Technical Service Information

THM 200-4R DELAYED REVERSE ENGAGEMENT 1988 - 1989 ONLY

Figure 1

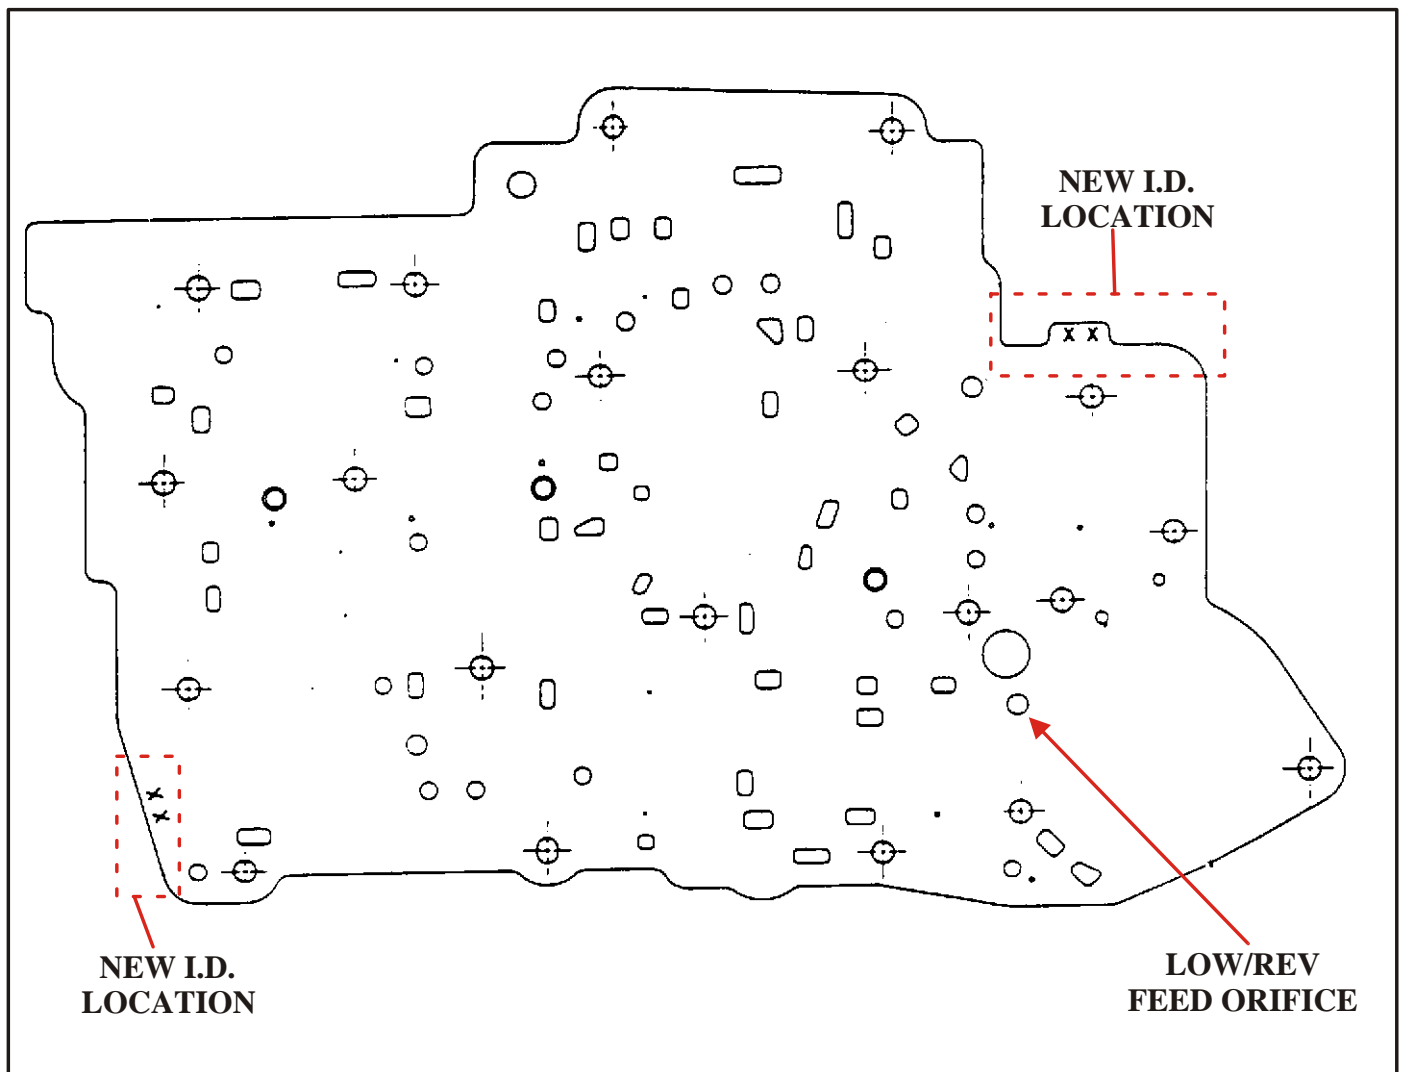
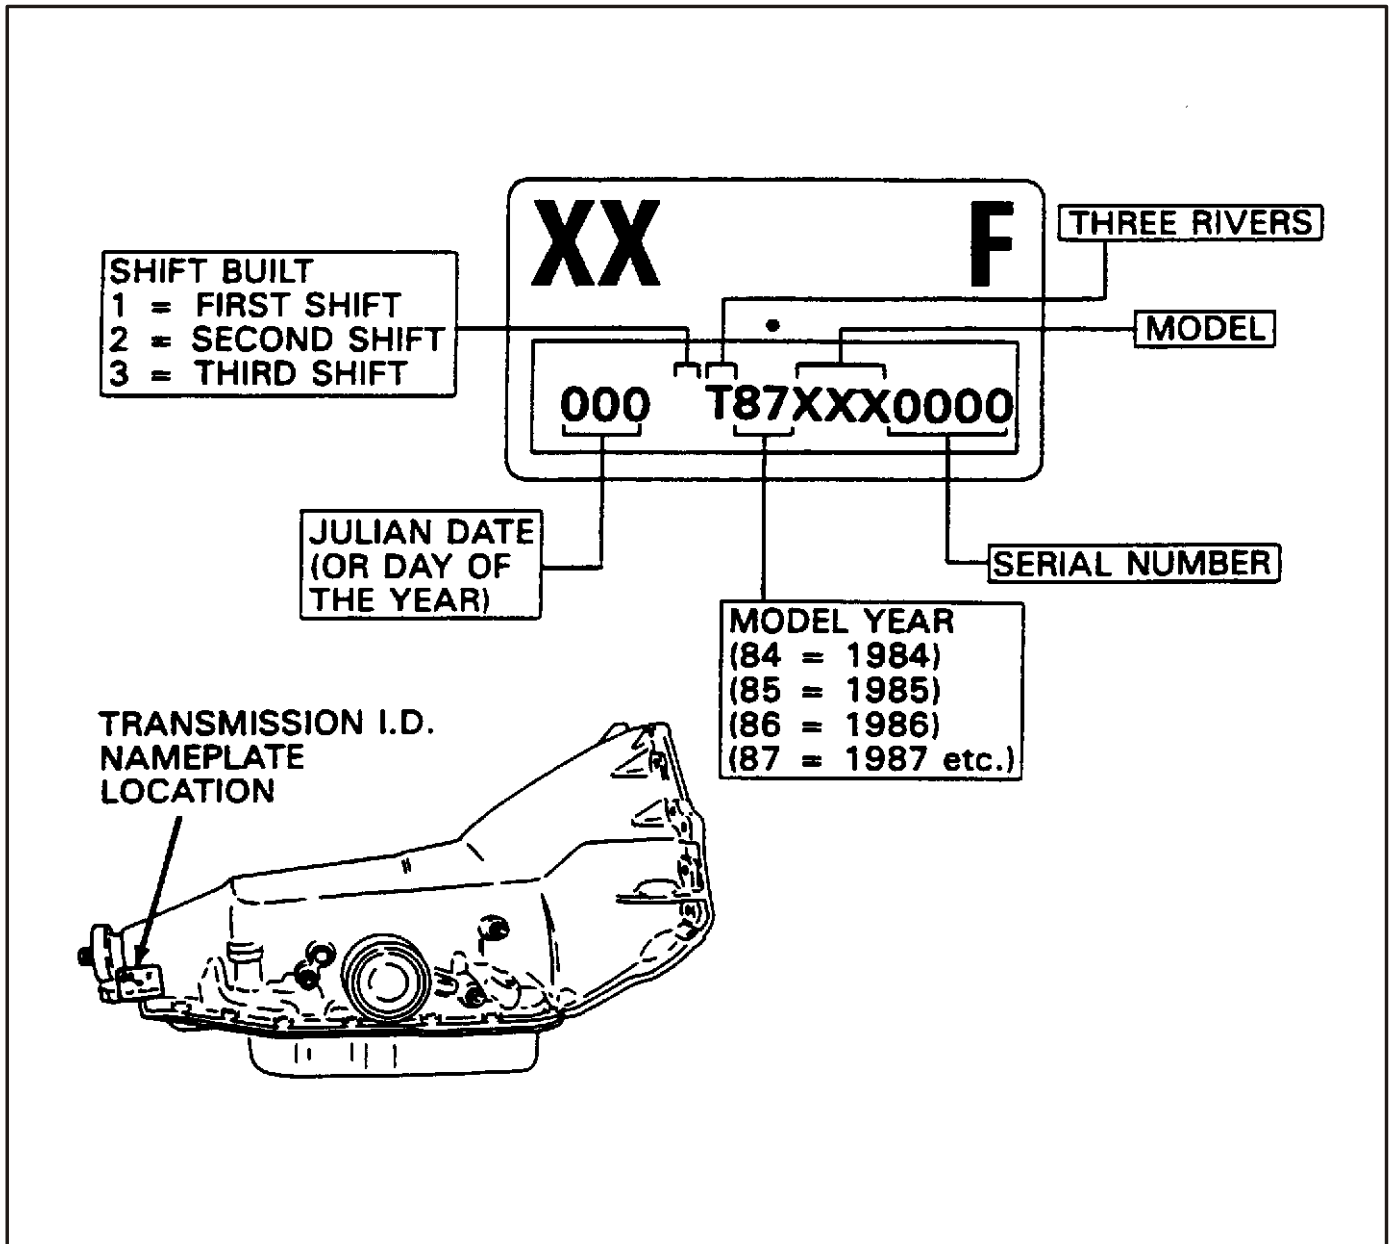
COMPLAINT: Some 1988-1989 THM 200-4R transmissions built after March 14, 1988 (Julian Date 074) and before July 7, 1989 (Julian Date 188) may experience a delayed engagement to reverse.

CAUSE: Valve body spacer plate calibration.

CORRECTION: Enlarge the LO/REVERSE feed orifice with a 1/8" drill bit. A revised spacer plate was used in all units produced after July 7, 1989. Refer to Figure 1 for orifice location in spacer plate.
